UNITED STATES PATENT AND TRADEMARK OFFICE

10/789,797

Office Action Summary	Application No. 10/789,797	Applicant(s) MILES ET AL.	
	Examiner ELLEN C. HAMMOND	Art Unit 3733

DETAILED ACTION

**FIG. 1**

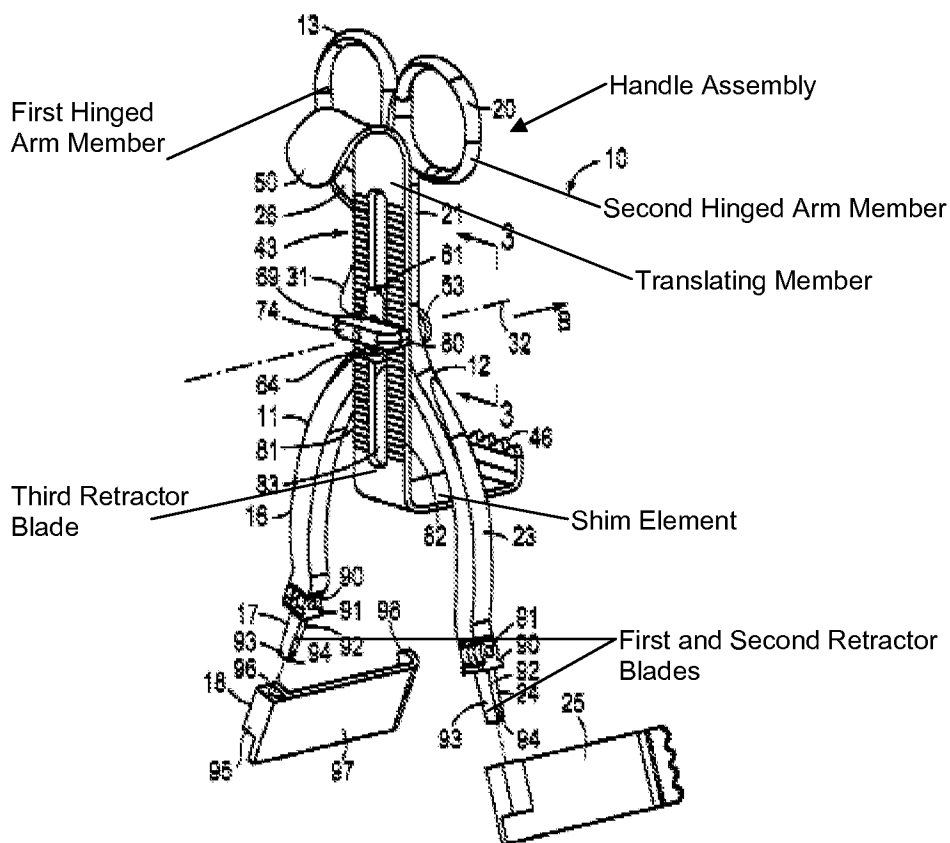
Concerning claim 20, Maeda et al. disclose a surgical retractor system for accessing a surgical target site, comprising a handle assembly (see Fig. 1 below) including first and second hinged arm members (see Fig. 1 below) and a translating member (see Fig. 1 below) adapted to move longitudinally relative to the first and second arm members, a first retractor blade (see Fig. 1 below) coupled to the first arm member prior to introduction into the surgical target site, a second retractor blade (see Fig. 1 below) coupled to the second arm member prior to introduction into the surgical target site, and a third retractor blade (see Fig. 1 below) coupled to the translating member prior to introduction into the surgical target site, the first, second, and third retractor blades defining a corridor extending from a proximal end of each retractor blade to a distal end of each retractor blade and between the retractor blades, the handle being operable to pivot the first arm and the second arm and to translate the translating member, thereby increasing the size of the corridor between the retractor blades to provide access to the surgical target site.

Concerning claims 24-26, the system further comprises a shim element (see Fig. 1 below) having an extension of sufficient length to extend past a distal end of the third retractor blade into a spinal disc space and of sufficient height to distract vertebral bodies adjacent to the spinal disc space. The shim (see Fig. 1 below) fixes the position of the third blade relative to the disc space when the extension is positioned in the spinal disc space. The retractor is configured such that the third retractor blade (see Fig. 1 below) can be fixed prior to enlarging the corridor and the first and second retractor blades move relative to the third retractor blade.

Concerning claim 27, the system further comprises a retractor extension, i.e., a shim element (see Fig. 1).
